Commonwealth Edison
 One First National Plaza, Chicago, Illinois
 Address Reply to: Post Office Box 767
 Chicago, Illinois 60690

Subject: Reactor Containment Leakage Testing for the Dresden and Quad-Cities Reactors, AEC Dkts 50-237, 50-249, 50-254 and 50-265

In response to your letter dated August 9, 1973, the following information is provided concerning the applicability of 10 CFR 50, Appendix J to containment leakage testing at Dresden and Quad-Cities. The numbering of the following responses corresponds to the numbering of requests in your August 9, 1973 letter.

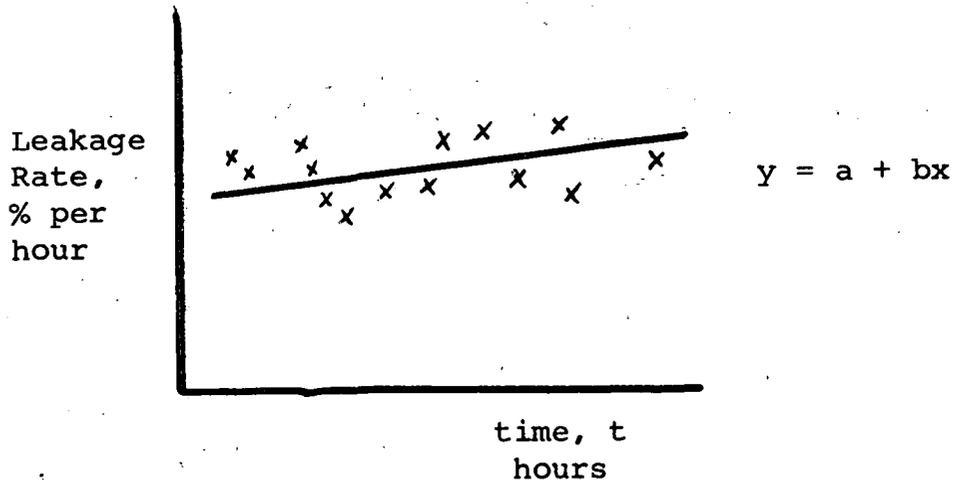
We feel that the use of a least-squares fit to the data to obtain an averaged hourly leakage rate is somewhat misleading. The method of least-squares says that, given a set of data, the line $y = a + bx$ will be the best "fit" to the data providing that the sum of the squares of the distance of each data point from the line is a minimum.

IPCLT data is a set of hourly leakage rates corresponding to specific times. For a leak rate line, $y = a + bx$, b should be close to zero because the leak rate should theoretically be constant. This would result in $y = a$ where "a" is a constant corresponding to the "statistically averaged hourly leakage rate." In reality, however, "b" will not be zero and the data fit will result in a line, $y = a + bx$, with a definite slope of "b". For example, using the least-squares fit could result in a

graph which looks like this:

Thus the only thing accomplished is a transfer of data points to a line. We still are faced with the problem of determining an average hourly leak rate. The uncertainty calculation, on the other hand, seems quite adequate, and we feel meaningful.
